Access Compliance Report

Public Rights-of-Way

(Pedestrian Signals)

Intersection ID: N/A	Main Street:	Cross Street: N/A	Location: N/A
ADA ID: C99B61C9EE66	Signal Type: One Push Button-Non APS	Overall Compliance: No	Severity Score: BTN 1: N/A BTN 2: N/A No BTN: N/A
Codes/Mitigation Info/Possible Solution		Field Measurements/Component Compliance

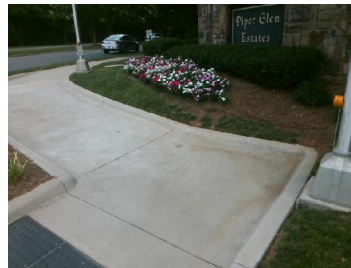
Compliance	Description	Data	Compliance	Description	Data
	Button Count	Button1	Yes	Distant to Additional Button (in)	312.0
	Additional Button Present?	Yes		Additional Button ID	F9BD5BBF5ECD
N/A	Signal Buttons Required?	N/A	N/A	Additional Ped Posts Required	N/A
	How Many Ped Street Xings?	2		Located In An Island/Median?	No
N/A	B 1 Sign Present?	Yes	N/A	B 2 Sign Present?	N/A
Yes	B 1 Sign Purpose?	Yes	N/A	B 2 Sign Purpose?	N/A
Yes	B 1 Sign Lettering & Contrast?	Yes	N/A	B 2 Sign Lettering & Contrast?	N/A
Yes	B 1 Parallel To XWalk?	Yes	N/A	B 2 Parallel To XWalk?	N/A
Yes	B 1 PAR to Button?	Yes	N/A	B 2 PAR to Button?	N/A
Yes	B 1 PAR to XWalk?	Yes	N/A	B 2 PAR to XWalk?	N/A
Yes	B 1 Clear Floor Space?	Yes	N/A	B 2 Clear Floor Space?	N/A
N/A	B 1 FWD Approach?	Yes	N/A	B 2 FWD Approach?	N/A
N/A	B 1 FWD Approach Constrained?	No	N/A	B 2 FWD Approach Constrained?	N/A
No	B 1 FWD Approach Reach (in)	12.0	N/A	B 2 FWD Approach Reach (in)	N/A

N/A	B 1 FWD Approach Width (in)	N/A	N/A	B 2 FWD Approach Width (in)	N/A
N/A	B 1 FWD Approach Obstruction?	Yes	N/A	B 2 FWD Approach Obstruction?	N/A
N/A	B 1 FWD Approach Obstruction Dist (in)	12.0	N/A	B 2 FWD Approach ObstructionDist (in)	N/A
N/A	B 1 PARA Approach?	Yes	N/A	B 2 PARA Approach?	N/A
N/A	B 1 PARA Approach Constrained?	No	N/A	B 2 PARA Approach Constrained?	N/A
No	B 1 PARA Approach Reach (in)	12.0	N/A	B 2 PARA Approach Reach (in)	N/A
N/A	B 1 PARA Approach Width (in)	N/A	N/A	B 2 PARA Approach Width (in)	N/A
N/A	B 1 PARA Approach Obstruction?	Yes	N/A	B 2 PARA Approach Obstruction?	N/A
N/A	B 1 PARA Approach Obstruction Dist (in)	12.0	N/A	B 2 PARA Approach ObstructionDist (in)	N/A
Yes	B 1 Clear Floor Space Slope (%)	1.5	N/A	B 2 Clear Floor Space Slope (%)	N/A
Yes	B 1 Clear Floor Space XSlope (%)	0.8	N/A	B 2 Clear Floor Space XSlope (%)	N/A
N/A	B 1 PAR Slope (%)	1.5	N/A	B 2 PAR Slope (%)	N/A
Yes	B 1 Height (in)	38.0	N/A	B 2 Height (in)	N/A

Yes	B 1 Clear Xing Direction?	ClearlyMarked	N/A	B 2 Clear Xing Direction?	N/A
	B 1 Crossing Direction	To SE		B 2 Crossing Direction	N/A
Yes	B 1 DistanceTo XWalk (in)	46.0	N/A	B 2 DistanceTo XWalk (in)	N/A
No	B 1 DistanceTo Curb (in)	90.0	N/A	B 2 DistanceTo Curb (in)	N/A
Yes	B 1 Diameter (in)	2.0	N/A	B 2 Diameter (in)	N/A

Possible Solutions: Replace Signal Push Button With APS Button on New Post. Remove & Relocate Sign.

PROW/ADA: TMUTCD 4e.08, R406.2, R404.7.3
